IMPORTANT MEDICAL DEVICE CORRECTION

CardioMEMS™ PA Sensor and Delivery System (Model CM2000),
CardioMEMS™ Patient Electronics System (Models CM1000, CM1010 and CM1100),
CardioMEMS™ Hospital System (Models CM3000 and CM3100)

February 2023

APPENDIX A: CARDIOMEMS™ PA SENSOR SETUP AND RESPONSE TO ERROR #8 MESSAGES

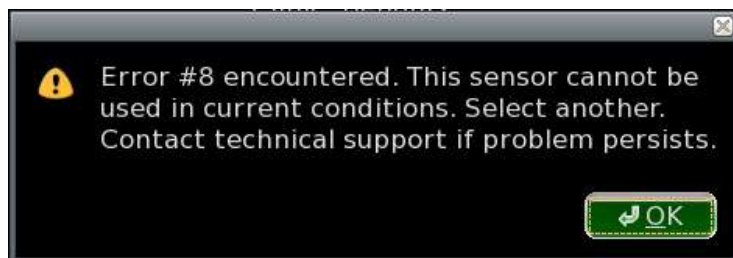
CardioMEMS™ Hospital Electronics System Model CM3000 with software version I2.2018.1105-r8829 and Hospital System Model CM3100 include an important software feature to identify CardioMEMS PA Sensors that are likely to operate above the intended radiofrequency range (between 30 and 37.5 MHz) as a result of internal sensor characteristics and current atmospheric conditions **pre-implant**. This software feature and the appropriate setup process is described below.

It is important to enter the data for CardioMEMS™ PA Sensors into the Hospital System prior to venipuncture during a sensor implant procedure.

PROCESS FOR CARDIOMEMS HOSPITAL SYSTEM MODEL CM3100
(software version CM3100.2022.0113)

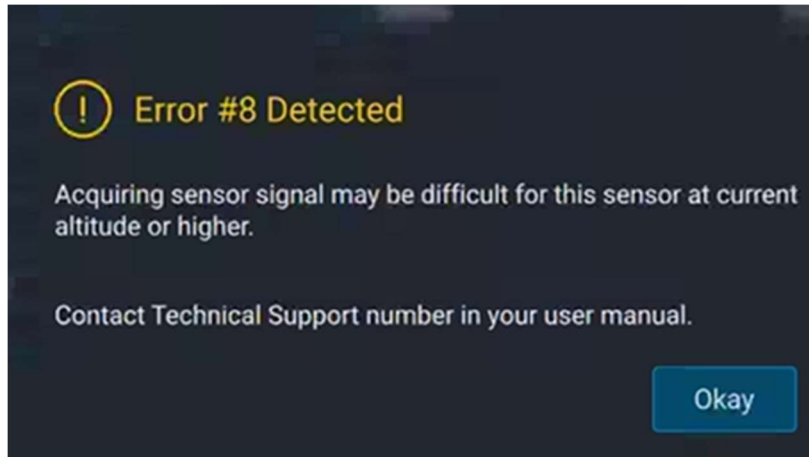
- Initiate a new implant session.
- Sensors must be set up on the patient information screen **prior to venipuncture and right heart catheterization** during a sensor implant procedure.
 - Setup consists of selecting the patient or entering patient name and Date of Birth, relevant physician information and inputting the Sensor Serial Number and calibration code, then selecting “Next.”
 - Once “Next” is selected, the software process to evaluate the sensor is executed.
 - If the sensor is not compatible with the current environmental conditions (i.e., the sensor may operate outside of the intended frequency range of 30 to 37.5 MHz), Error #8 will be displayed at this time.

- If an Error #8 message occurs, the sensor is not compatible with the environmental pressure conditions and **should not be implanted**. Users must **select and set up another sensor** in order to complete the implant procedure.
- Once the Error #8 message is acknowledged by selecting “Okay,” the implant procedure may continue; however, the sensor may be subject to increased measurement inaccuracy or signal acquisition.
- **Until the software is updated, it is important for Users to select another sensor and return the out of range sensor to Abbott for exchange.**
- **Return to the patient information screen** by pressing “Edit” on the Confirm Patient Information page, clear the current Serial Number and Calibration Code, and **input a new Sensor Serial Number and Calibration Code** in order to complete the implant procedure.
